CITY OF ALLENTOWN

R55 – 2025

Certificate of Appropriateness for work in the Historic Districts:

Historical Architectural Review Board
COA Preliminary Review Sheet

Proposed Lift (Applicant)

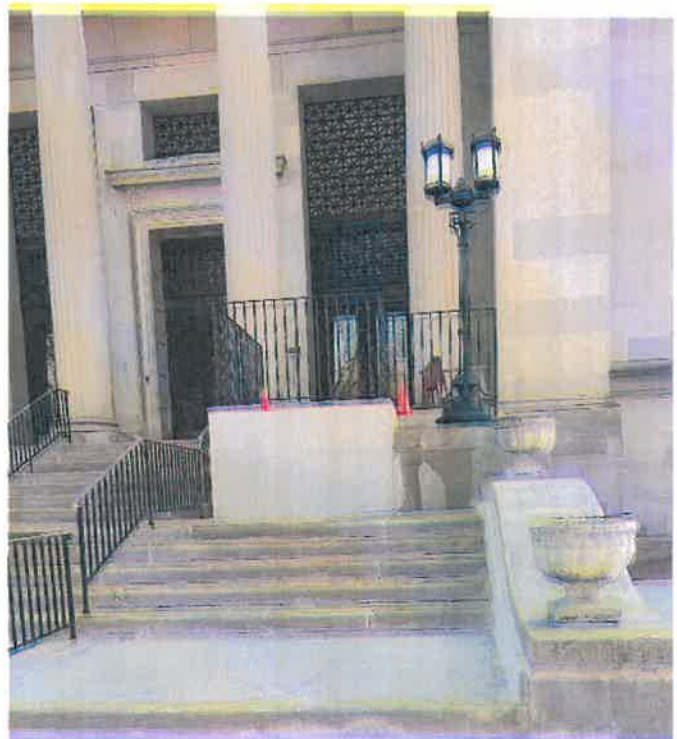
The completed work to date includes a new at-grade sidewalk, a formed concrete landing over the top of existing stairs, metal railings at this new landing, and concrete fill over existing tiles at the existing entry door.

While providing an accessible entry at the main entry is desirable, the top landing does affect the composition of the front elevation and the original historic entry. Given that the first floor is quite elevated above grade and there are limited access points to the building, providing an accessible entry would be challenging. More information from the applicant would be helpful to understand the process for coming to this solution and if other options were explored, such as a ramp, and if there were dimensional requirements that resulted in the top landing extending past the lamppost.

The Guidelines recommend considering provisions for reversibility so that modifications can be easily removed without damaging historic fabric in the future. It appears in the photos that concrete was built up over the existing stairs and tiled entryway. Any future removal of this concrete may compromise the integrity of the historic materials.

The new railings at the top landing are similar to the existing stair railings in materiality and finish but appear to have a different profile.

Information has been submitted regarding the configuration of the lift. The metal components in the sample image appears to be a buff color. A color that complements the existing surrounding stone would be appropriate. It would be helpful for the applicant to confirm the intended finish color of the lift.

Staff Recommendation: Staff recommend denying the application.

Rear of Property (Google Maps, October 2014)

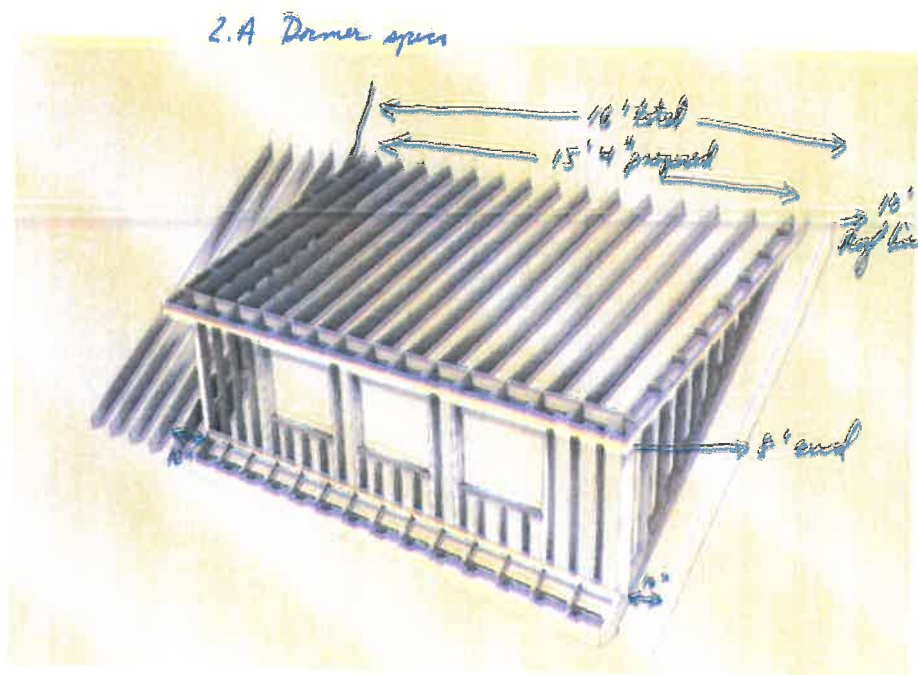
- **Rear Windows:** Remove rear second floor bathroom window and infill with brick, due to interior modifications. Replace other rear second floor window in a new configuration due to interior modifications, reducing the height of the window opening.

Example dormer framing heights (Applicant)

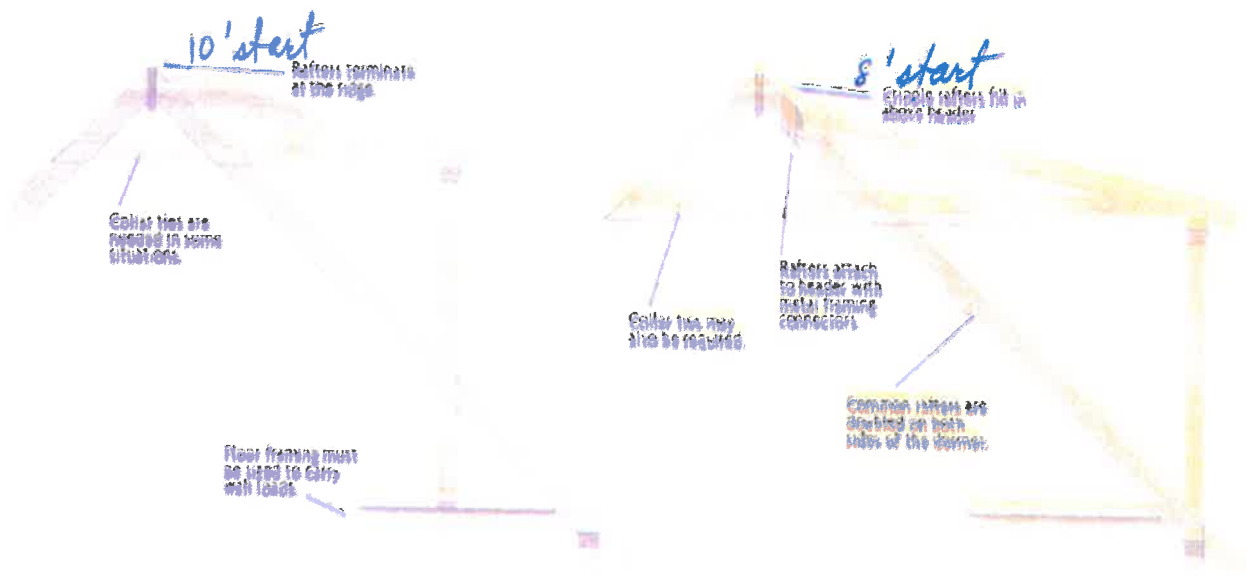
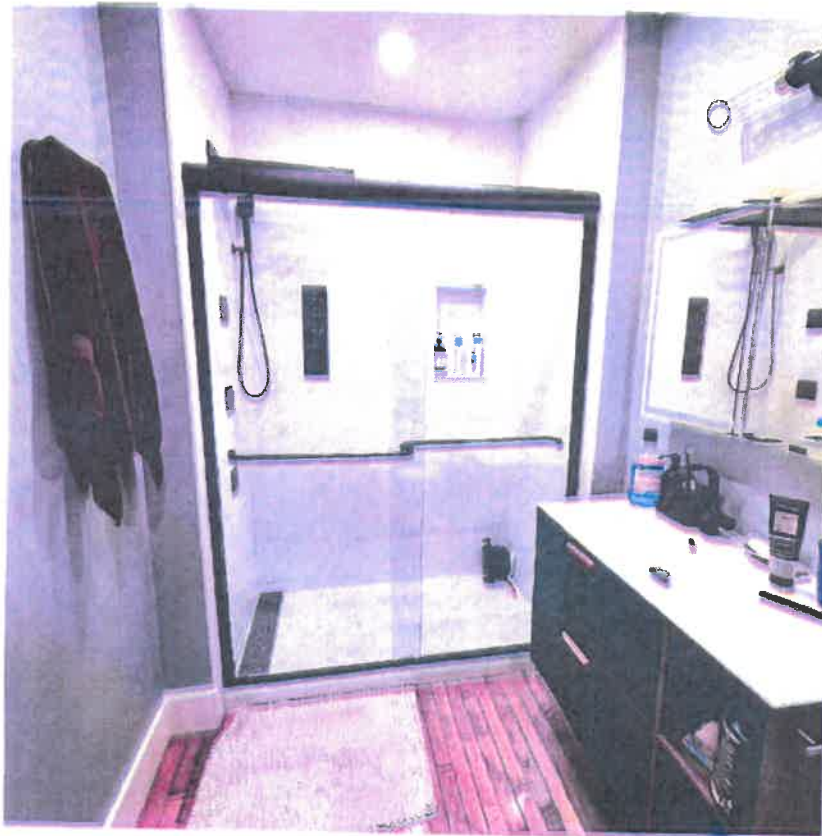
The dormer will be further designed by a design professional, but Mr. Lunes wanted to confirm that the intent and approach to the design is appropriate before proceeding. A staircase in the middle of the room in the attic is a constraint on the configuration of the dormer, but the proposed rear dormer would provide more functionality to the layout of the building. Mr. Lunes noted that the windows on the dormer would be 1/1 aluminum clad wood, which Mr. Huber noted that that would be appropriate, and that replacement windows on the rest of the building should be 2/2 aluminum clad wood to match the original in configuration. Applicant to provide more information on condition of windows proposed to be replaced.

Actions: Mr. Encelewski moved to approve the application presented on April 7, 2025, for the proposed rear dormer and window modifications at 627 Liberty Street with the following conditions agreed to by the applicant following sections of the Guidelines for historic Districts: Chapter 3, 3.3-Masonry, 3.5-Windows, 3.6-Doors, 3.12-Fences and Streetscape Features, and 4.1-Additions to Existing Buildings and find no circumstances unique to the property:

Rendering of proposed work, view from east. Existing building with proposed addition/exterior work indicated by yellow star. (Applicant)

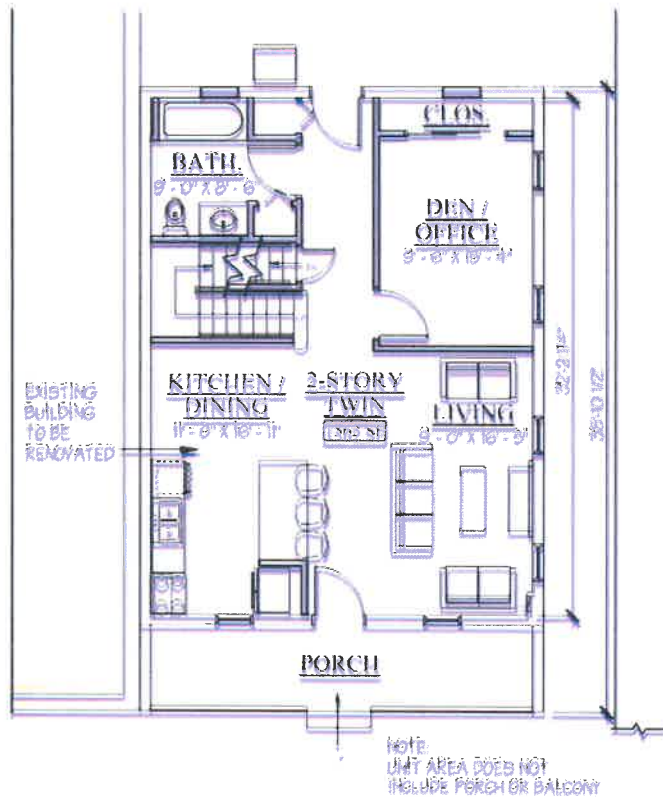
The proposed project is to construct an addition and conduct exterior modifications to the existing 1-story structure. A new construction apartment building is proposed on the same parcel, and is described in HDC-2025-00015. No modifications are proposed to the existing 2 ½ story structure.

Actions: Mr. Hart moved to approve the application as presented on April 7, 2025, for the addition and exterior modifications at 424 N 11th Street, following sections of the Guidelines for Historic Districts: Chapter 4, 4.1-Additions, and found no circumstances unique to the property. Ms. Westerman seconded the motion, which carried with unanimous support and no abstentions.

Elevation of proposed work. Proposed new building indicated by red star. (Applicant)

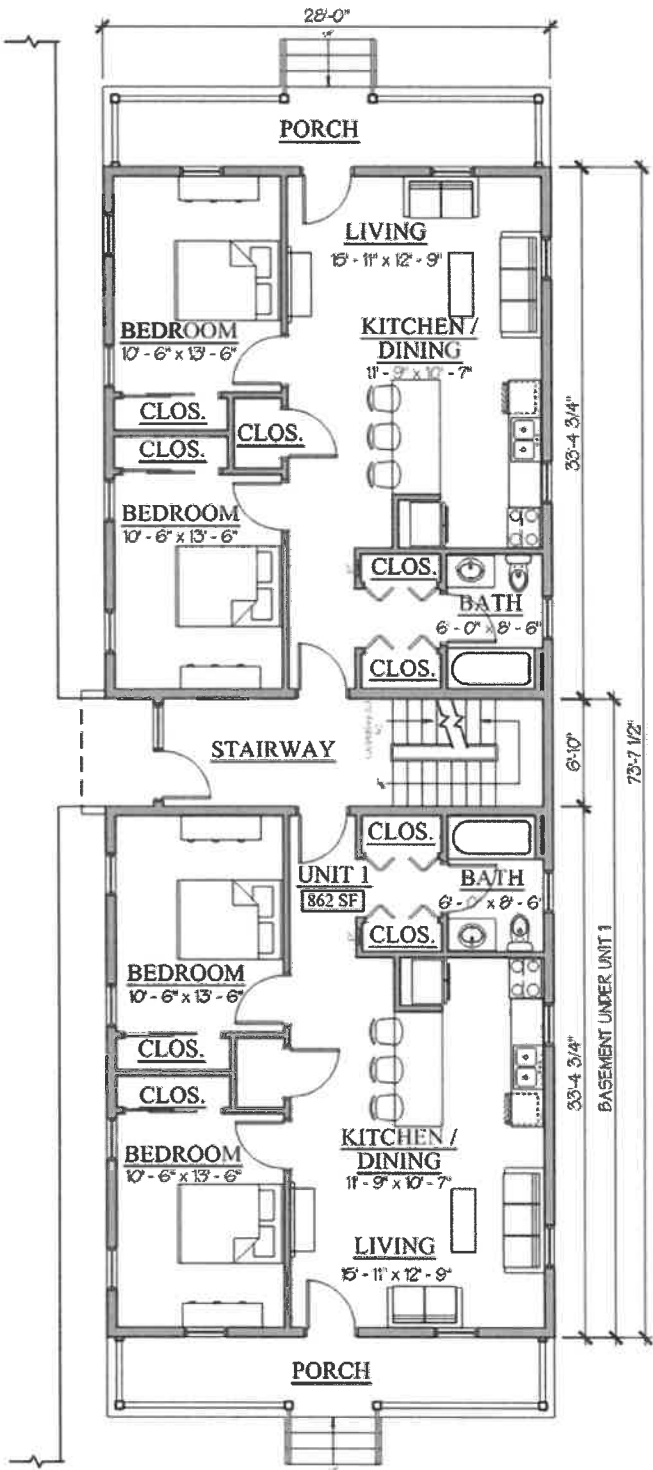
The proposed project is to construct a new apartment building in an open portion of the parcel. An addition to the 1-story structure is described in HDC-2025-00016. No modifications are proposed to the existing 2 ½ story structure.
